March 19, 2015
ADDENDUM #2
TO
REQUEST FOR OFFERS TO PURCHASE
FOR
THE SALE OF REAL PROPERTY
HOWARD COMMONS

Issued by the
FORT MONMOUTH ECONOMIC REVITALIZATION AUTHORITY

This ADDENDUM is being issued to answer questions received via email:

TEST PIT LOCATION PLAN

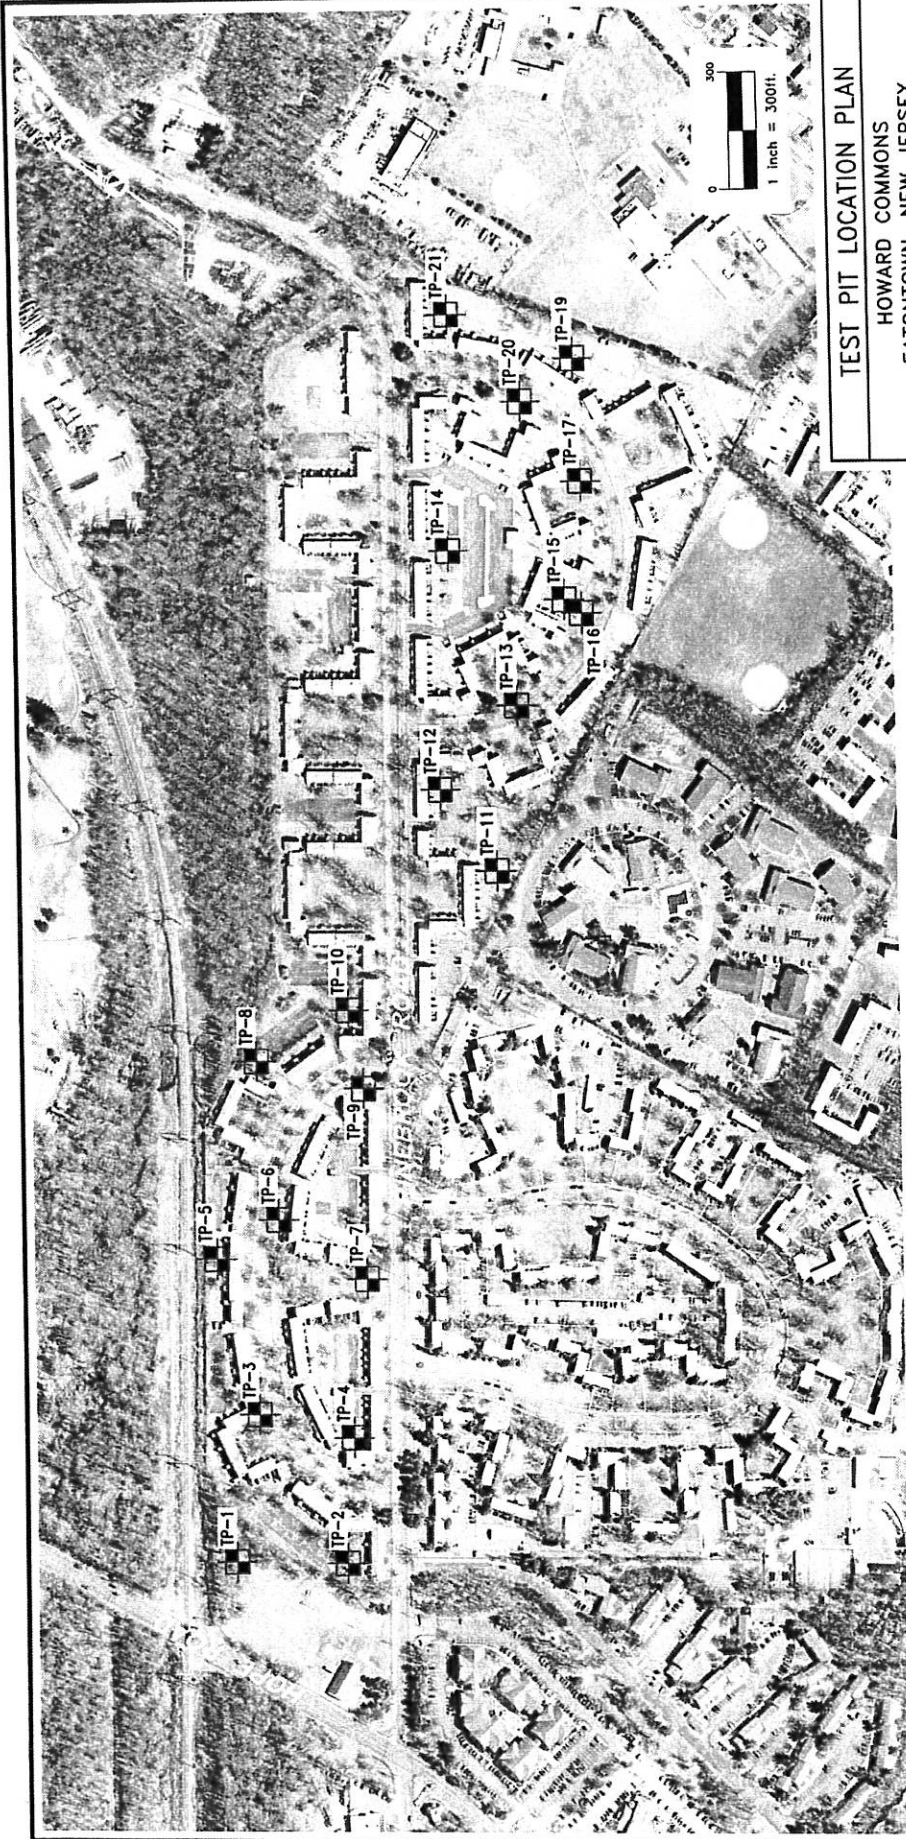
- Q:** All asbestos surveys related to the Property.
A: Exhibit A, attached, is the latest and only report available however, the Army has ascertained that all asbestos was removed from the buildings during the gut/renovation that occurred in the early 1990s, as a result the buildings were not re-inspected or surveyed.
- Q:** All investigations, feasibility studies, soil borings, surveys, asbestos reports, site plans, environmental studies, geotech reports, ect. which the former prospective purchaser (KHOV) had completed during their due diligence of the Property.
A: The only information FMERA received from KHOV was a test pit location plan and a matching chart listing the depth to groundwater found in Exhibit B (attached)
